# The HUB - Indoor Pickle Ball

Site Plan: SP-xx-xxxx

GRADING & DRAINAGE PLAN  
 UTILITY PLAN  
 TREE PROTECTION PLAN

GR1

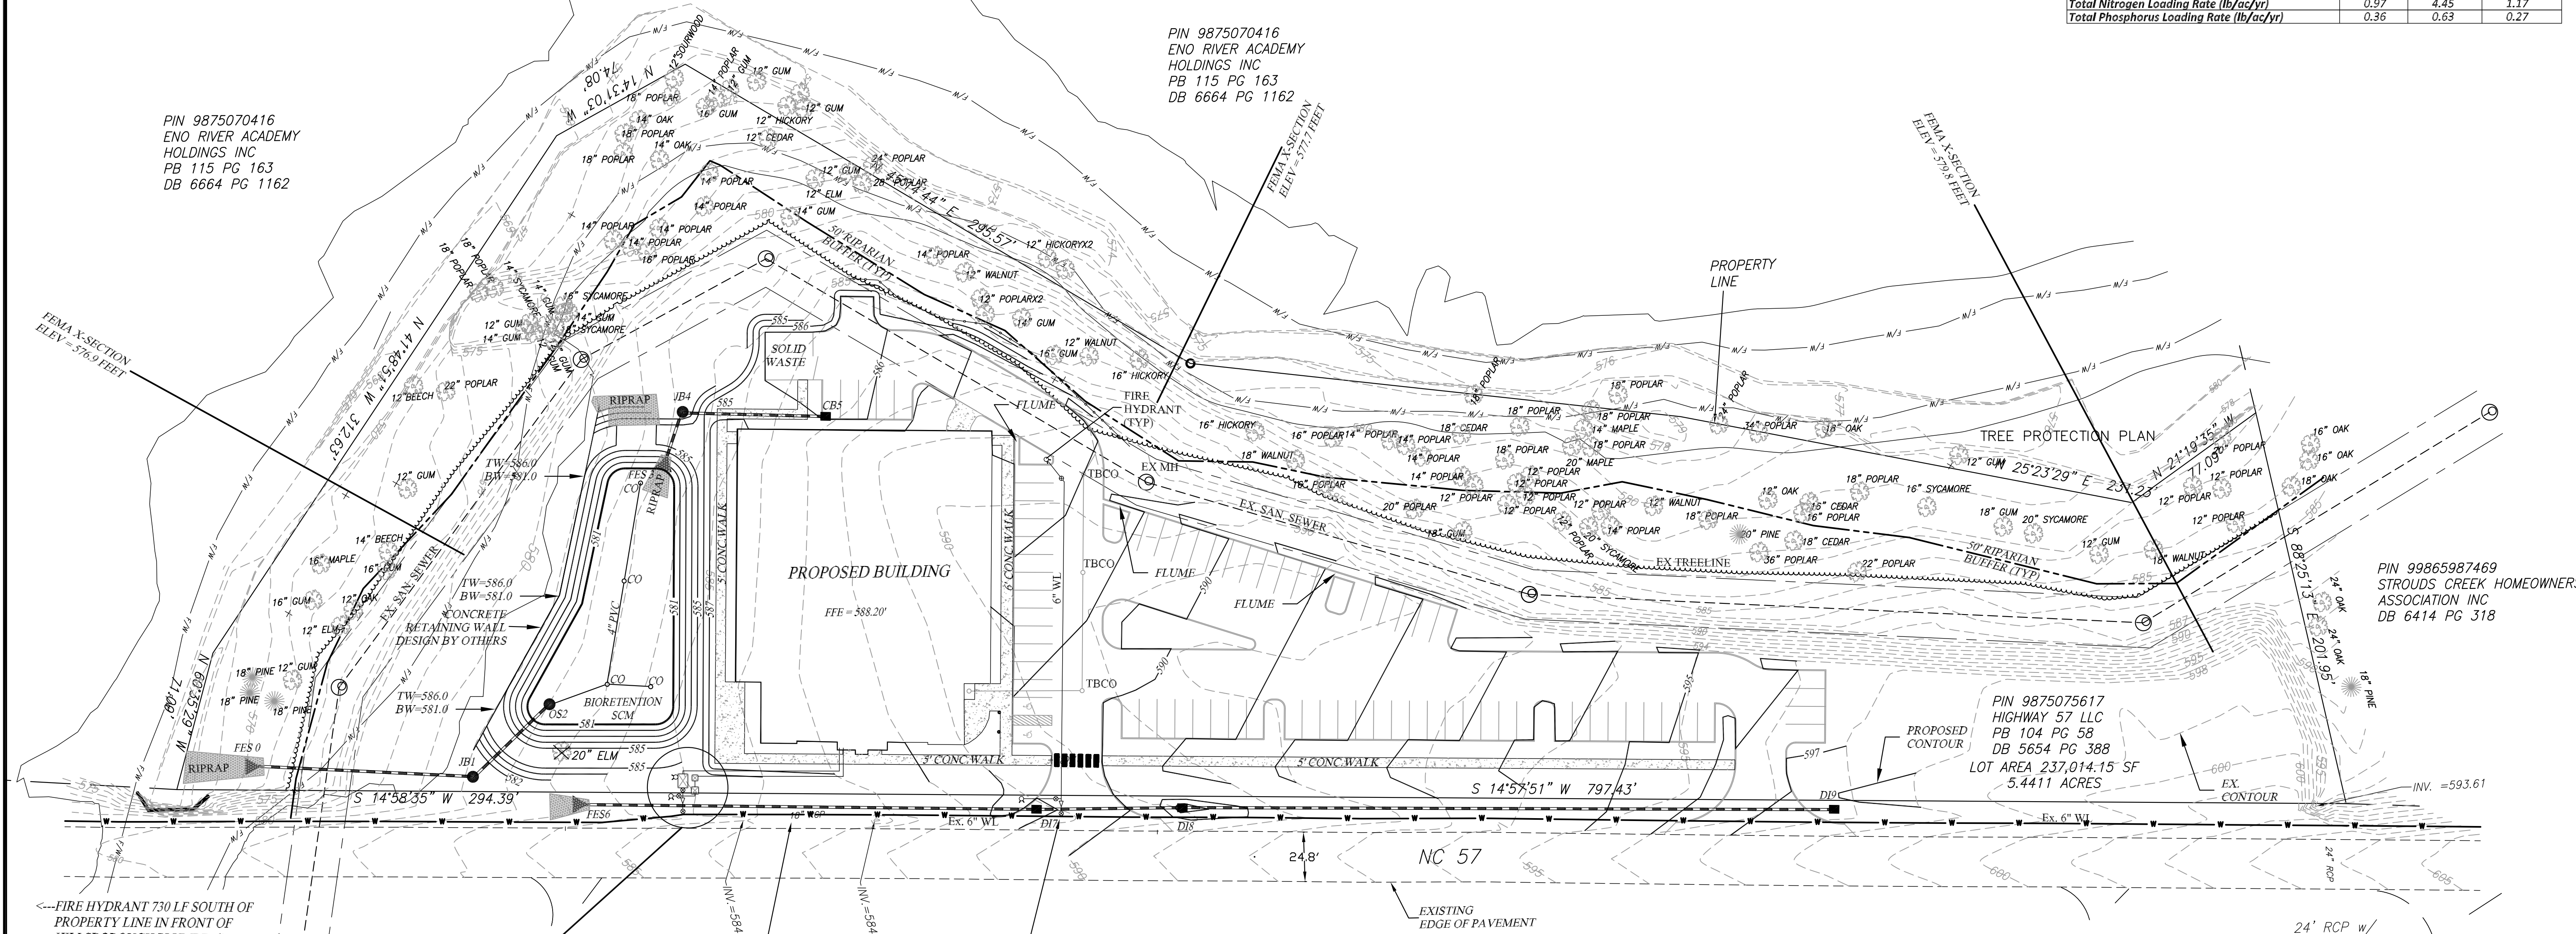
How are you going from 6" to 1.5"? Are you putting a reducer here?

Connection must be a cut in T with an in-line valve. No reducers or increasers.

- 1-6" x 4" - TAPPING SLEEVE W/ 1/4" VALVE
- 1-4" x 6" - INCREASER
- 1-6" x 6" TEE
- 1-6" GATE VALVE
- 1- FIRE HYDRANT

1 LANDSCAPE PLAN  
L-5 SCALE: 1"=40'

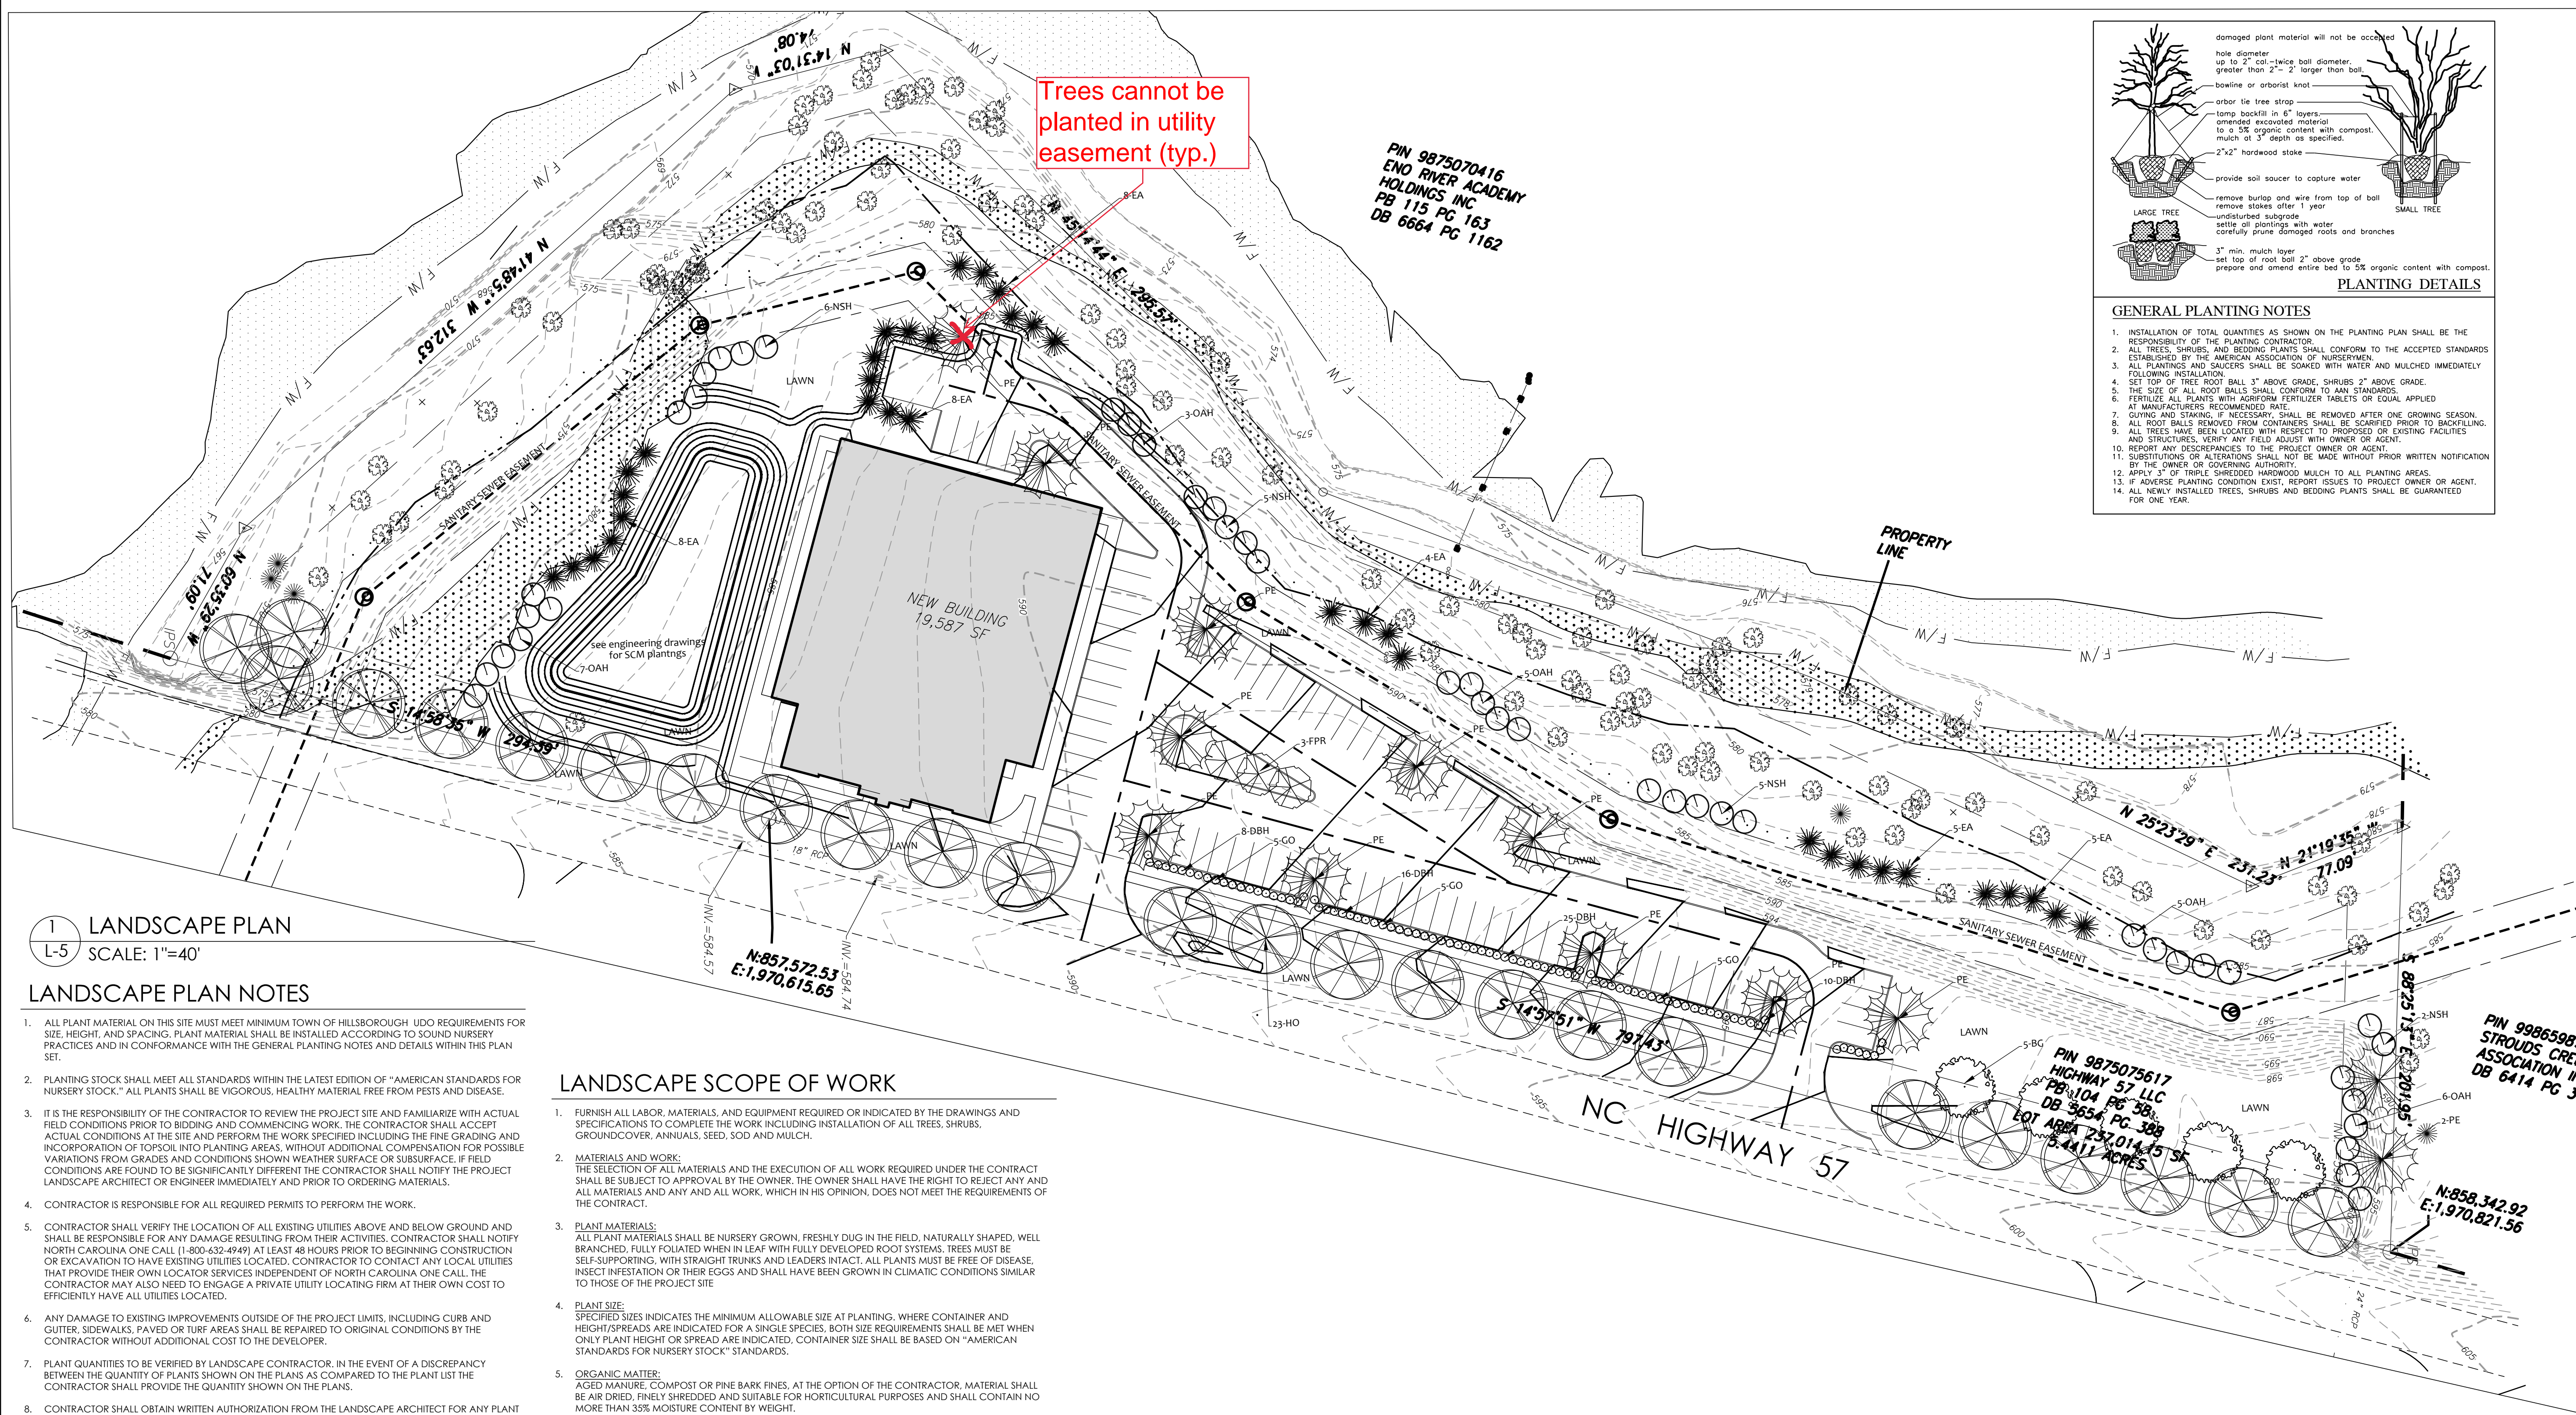
Trees cannot be planted in utility easement (typ.)
